# **3 Volt Intel StrataFlash<sup>®</sup> Memory**

## **28F128J3A, 28F640J3A, 28F320J3A**

### **Specification Update**

Order Number: 298130-014

Figure 1. AC Waveform for Standard Word/Byte Read Operations

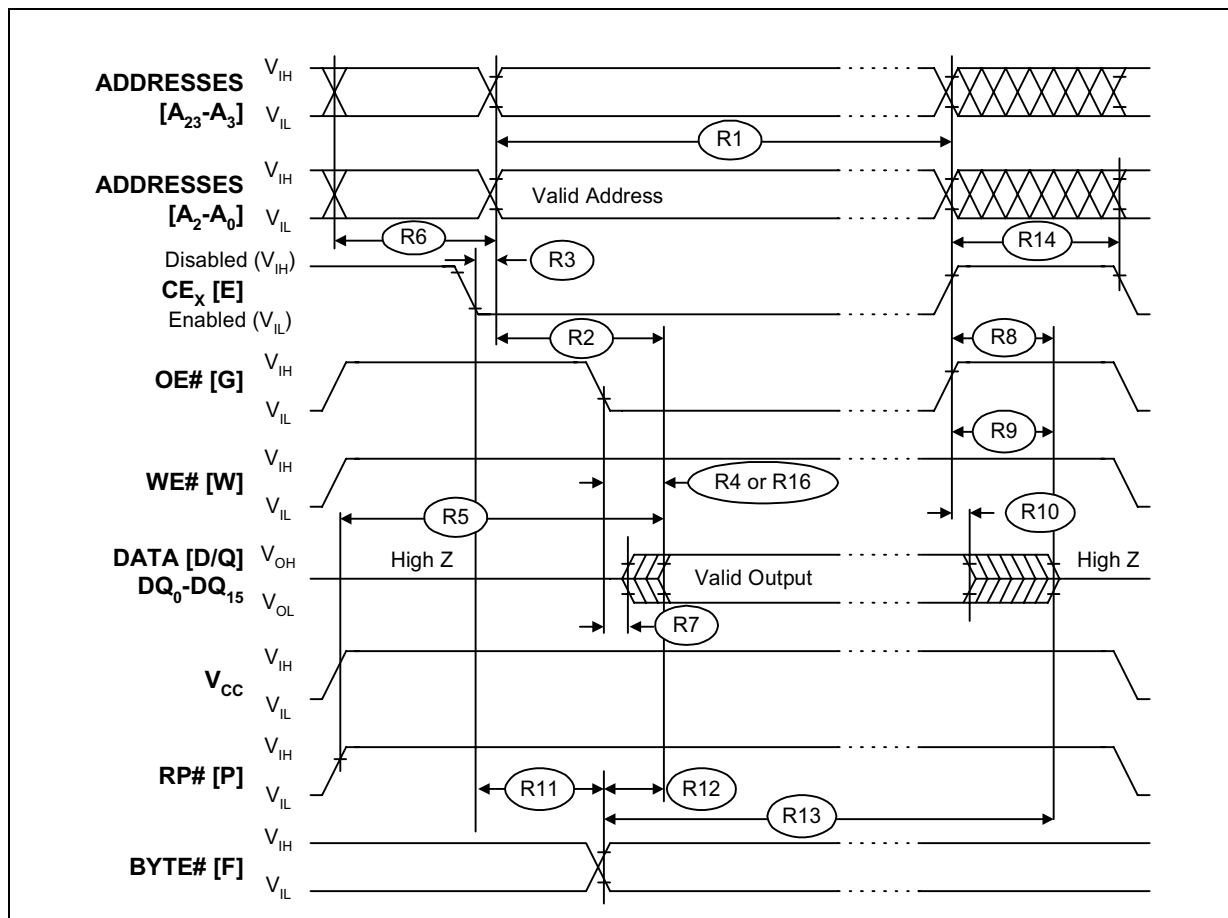
Problem: Devices need the parameter  $t_{ELQX} = 150$  ns minimum. CE low to output in low Z ( $t_{ELQX}$ ) is designated as R6 in Figure 1, in this Specification Update revision.

Problem: Devices need the parameter  $t_{ELAV} = 500$  ns maximum. Chip Enable to Address Valid ( $t_{ELAV}$ ) is designated as R3 in Figure 1, in this Specification Update revision.

Problem: The parameter  $t_{ELQV}$  has been deleted.
